SAFETY EVALUATION REPORT  
MODIFICATIONS TO THE BOILING WATER REACTOR (BWR) EMERGENCY PROCEDURE  
GUIDELINES TO ADDRESS REACTOR CORE INSTABILITIES

### Staff Evaluation of BWROG Response to Draft Safety Evaluation of Proposed EPG Modifications

Figure A.1 Effect of Collapsed Level on Core Thermal Power

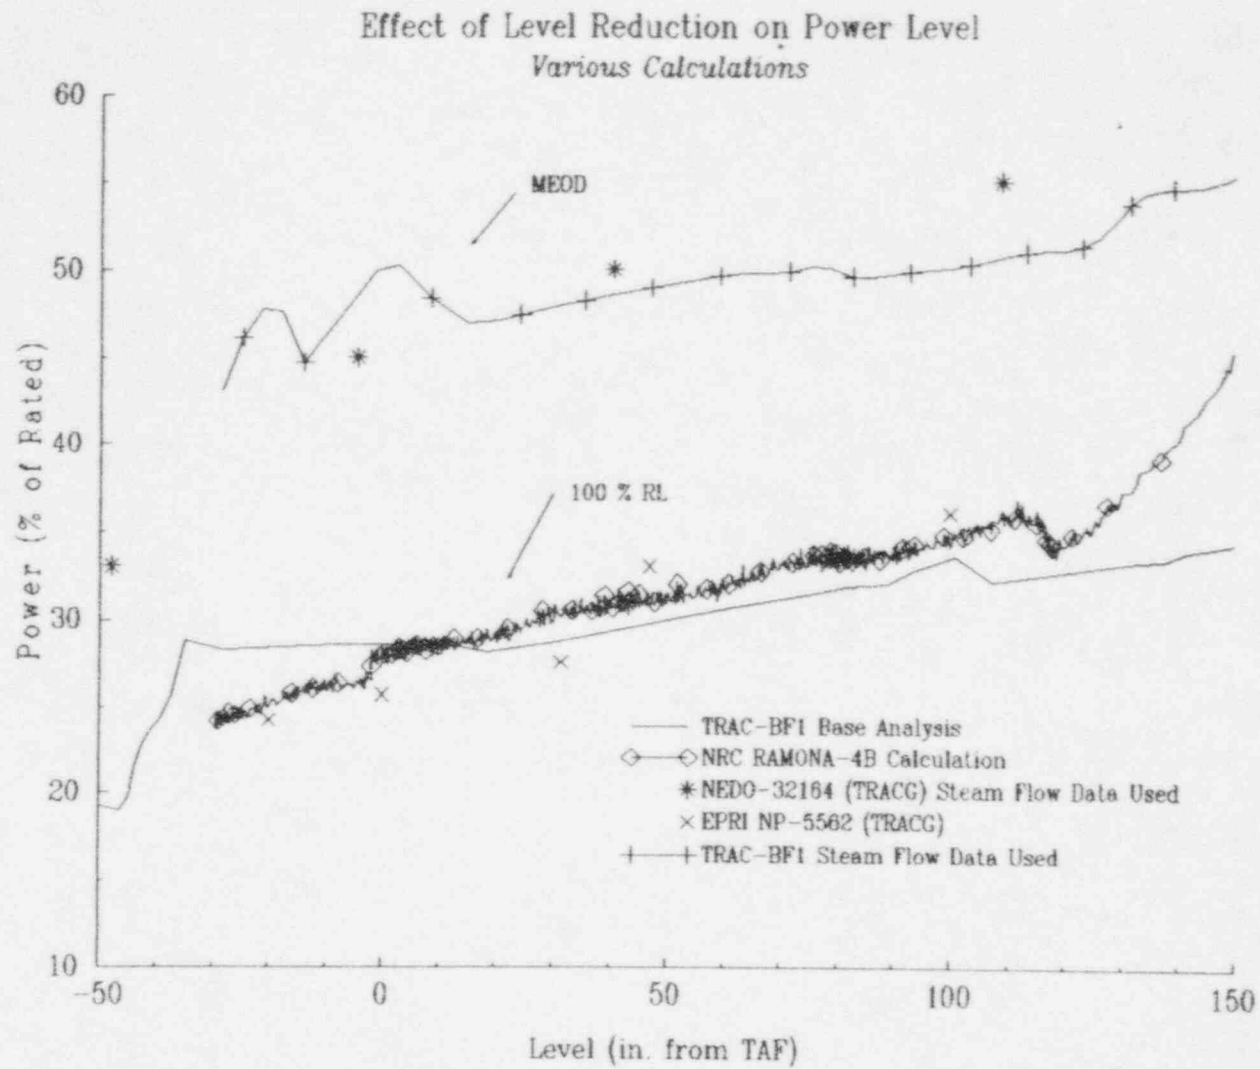
The data from these sources were used to produce Figure A.1 which plots the power as a function of collapsed level. With the exception of the TER results, the staff interpolated core power levels from published plots. For the NEDO-32164 results, the staff used the values for the vessel steam flow and, after accounting for condensation effects in the presence of cold feedwater, determined a reactor power level. This was necessary because the calculation involved an instability and the power level was impossible to determine accurately. Brookhaven National Lab performed additional calculations with RAMONA-4B and the staff completed numerous TRAC-BF1 sensitivity calculations that are not specifically reported here. All of these sensitivity studies show the same trend as the data plotted in Figure A.1.

The results of the suppression pool calculation are presented in Table A.1. As can be seen, the TER results compare well with NEDO-32164 results; the SABRE results show an additional 5 minutes of margin; and EPRI NP-5562 results show an additional 3 minutes of margin. The conclusion that the staff draws from these results is that there remains a great deal of uncertainty in the calculated time to HCTL because of differences in codes and analytical assumptions. Furthermore, the additional time gained at low level is not significant enough to procedurally account for the low probability event of an SLC system failure due to the adverse impact on the higher probability SLC operable event. In other words, the staff

concluded that the potential recovery actions that operators may take in the additional 3 to 6 minutes gained by low-level control will not significantly alter the overall risk.
